WASHINGTON UTILITIES AND TRANSPORTATION COMMISSION

DOCKET NO. TR-	
BNSF Railway Company	PETITION TO MODIFY WARNING	J
Petitioner,	DEVICES AT A HIGHWAY- RAILROAD GRADE CROSSING)) 1
VS.	15/02 Solution to the second s	1, M
Washington State Dept. of Transportation	USDOT: 099190G	Re
Respondent	16:1 ASIO SSIO	ceive
		g g

1. Existing highway/roadway SR-22 (Buena Way) at MP 3.19
2. Existing railroad <u>BNSF Railway Company</u>
3. USDOT Crossing No099190G
4. GPS location 46.380381, -120.314948
5. Railroad mile post (nearest tenth) 71.4
6. City Toppenish County Yakima

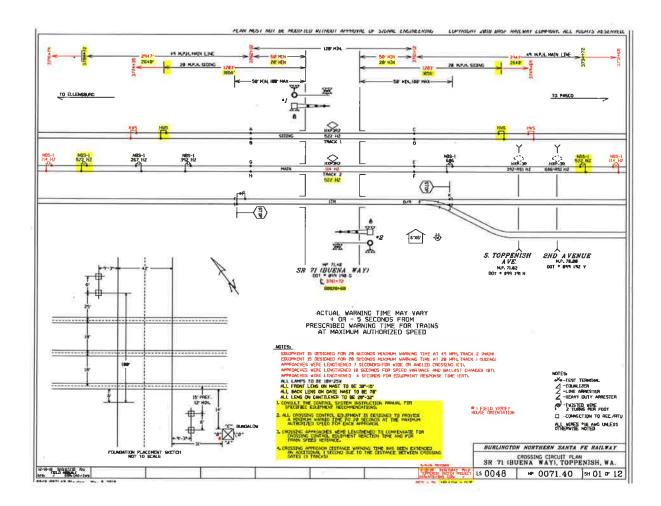
Changes would be to remove the predictor circuit on one other than main track, and provide an island circuit with stop and wait signs. The stop and wait signs are for display and viewing for trains only, and will have no effect on vehicular traffic. This change would reduce the potential of false activations by removing a predictor circuit on a track that is not frequently used, which means that the track can rust over time and provide inaccurate train predictions. The stop and wait signs would solve the track issues that could arise at this particular location. Attach a detailed design diagram, drawing, map or other illustration showing all proposed modifications, including signals, signage, pavement markings, sidewalks, etc.

In the below drawing, the siding track would be converted to match the 1TR. Hard Wire shunts (HWS) would be removed, and stop and wait signs added.
